Subject: Fire Extinguisher Requirements RFI 49

OVERALL FLOOR PLAN

GRIZZLY DISTRIBUTION CENTER
LYCOMING MALL RD. – Lycoming County, PA

1 FLOOR PLAN
SCALE : 1"=20'-0"

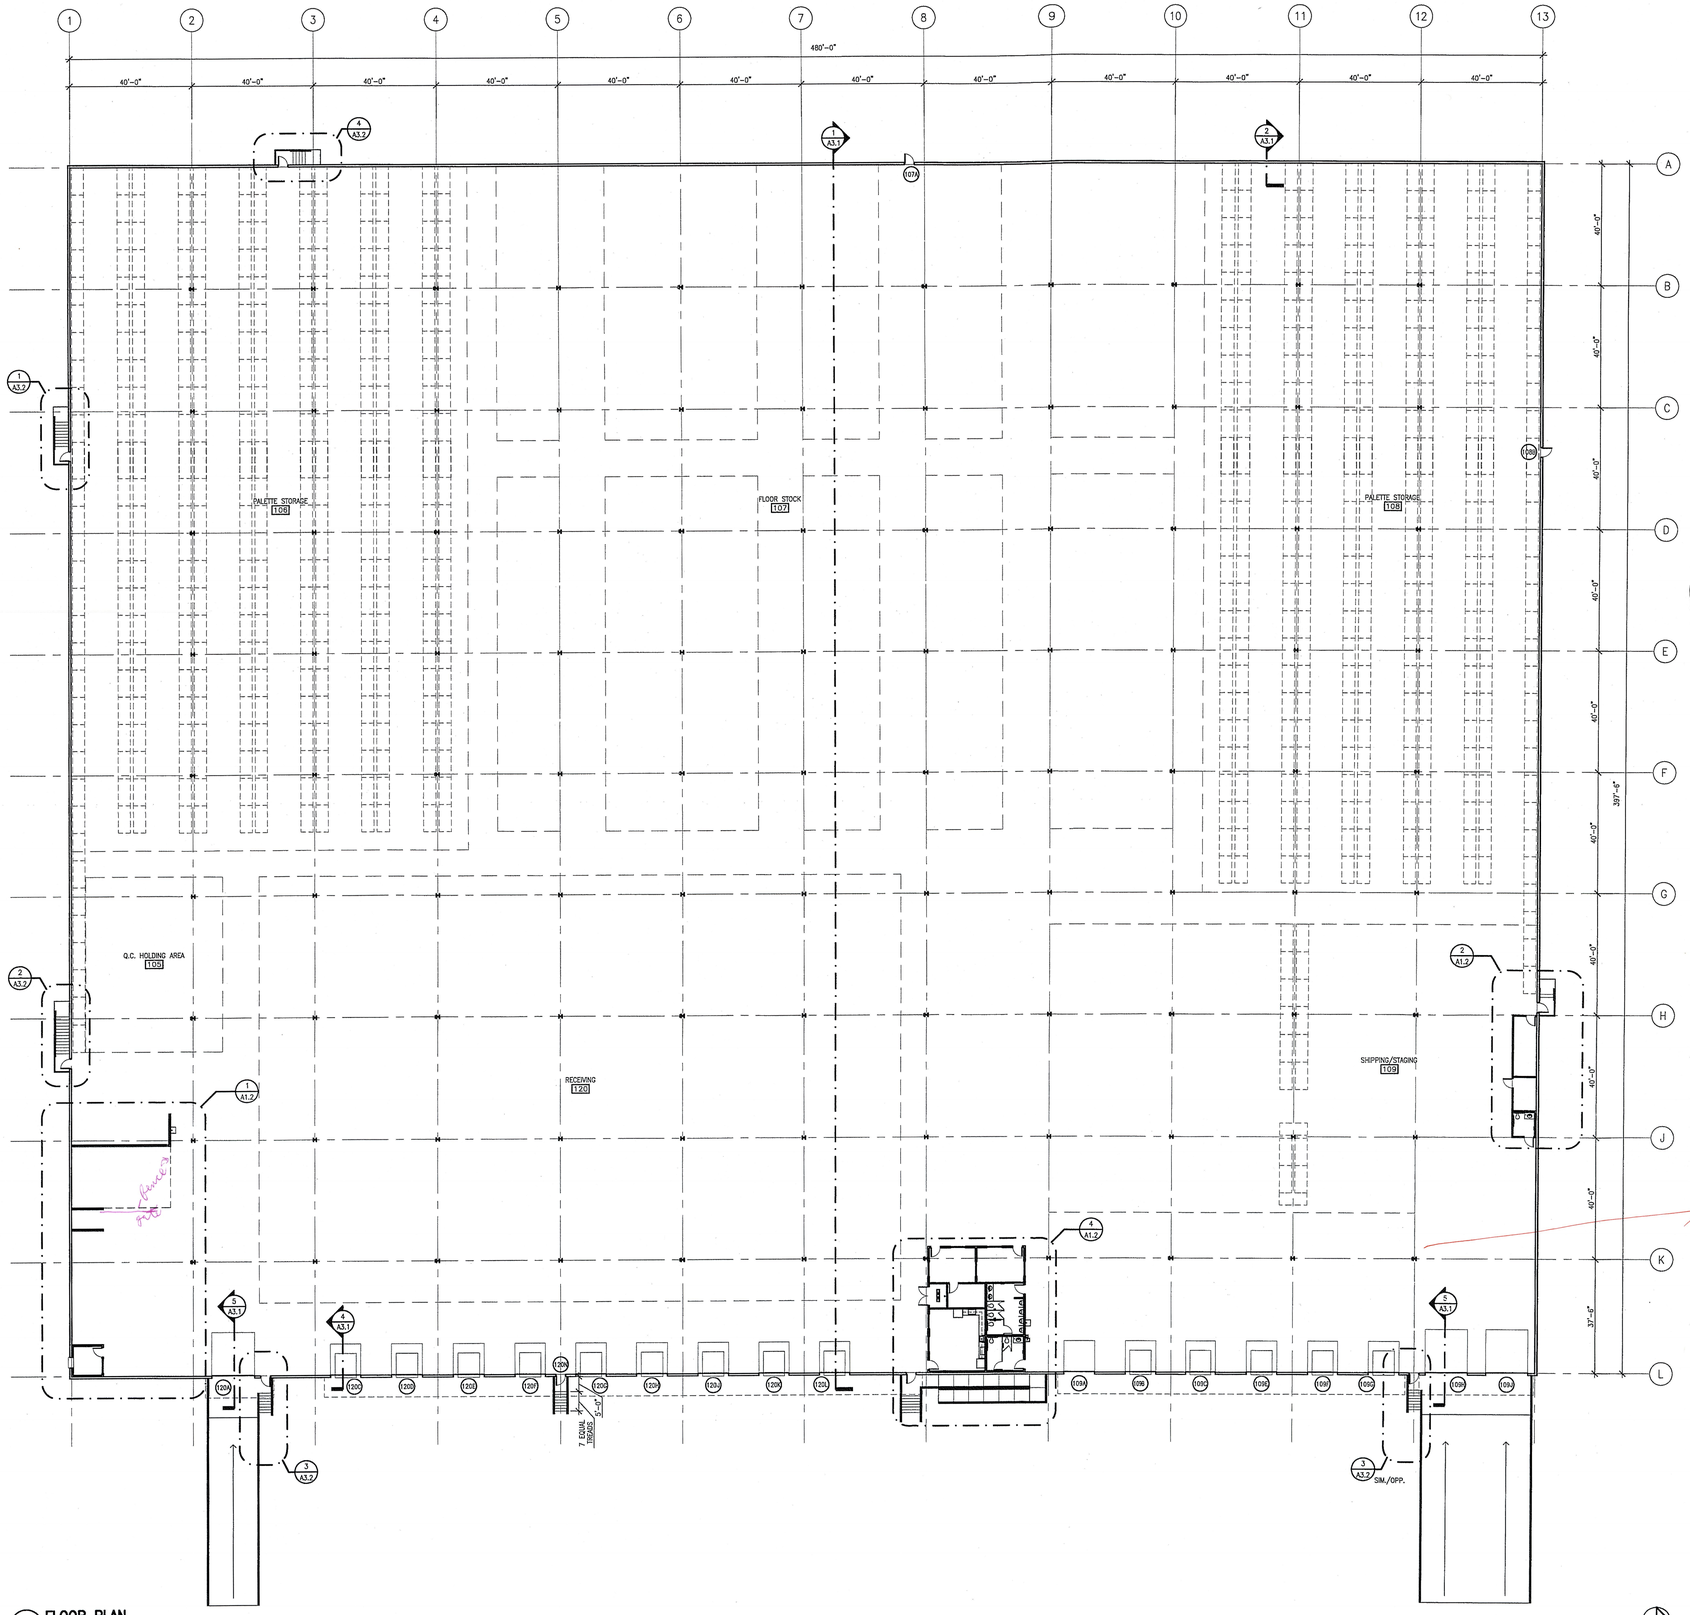
The project documents state that surface mounted fire extinguishers are to be mounted at every other column (75' max radius). Since columns are currently 40' apart, spacing the extinguishers at every other column would exceed the maximum radius of 75'. Does this mean fire extinguishers are to be located at every column? Please advise how the fire extinguishers are to be layed out.

The fire extinguishers must cover a 75' radial area max, therefore they can be 150' from each other – spacing them at every third column (120' between each other) east to west and every second column (80') north to south will provide the overlap of coverage required. Refer to the attached (Fire Extinguisher Layout.pdf).
